VKMA 01130 / 01275

Technical Bulletin - February 2012

AUDI, SEAT, SKODA, VW

SKF kit replacement: VKMA 01275 is replaced by VKMA 01130

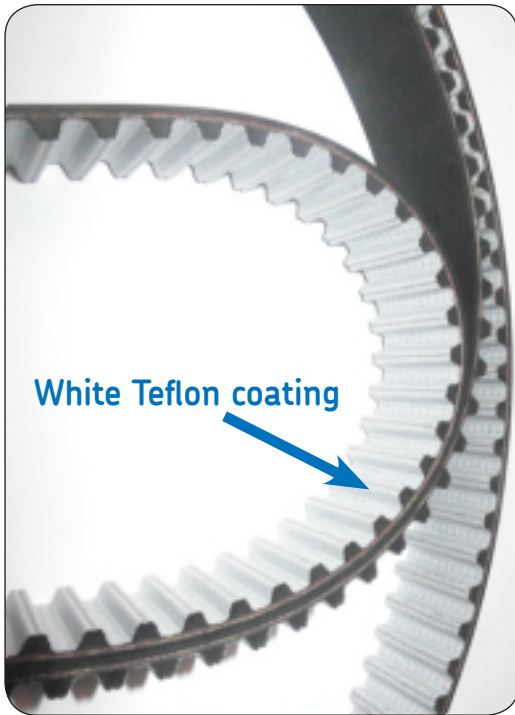
In accordance with OE specifications, the difference between the SKF timing belt kits VKMA 01130 and VKMA 01275 is the belt - both belts have same physical dimensions, but a different construction.

In-line with the OE belt material change, the belt included in the VKMA 01130 kit has been manufactured with a stronger construction. Today, car makers only use this unique, reinforced belt in the kits - therefore, SKF has also superseded the VKMA 01275 kit with VKMA 01130.

With this OE evolution and specification change, the belt material has been modified and now includes a Teflon coating.

The Teflon coating/design ensures a stronger resistance and extends the timing belt kit change interval from 90,000 to 120,000 km (or 5 years, whichever is soonest).
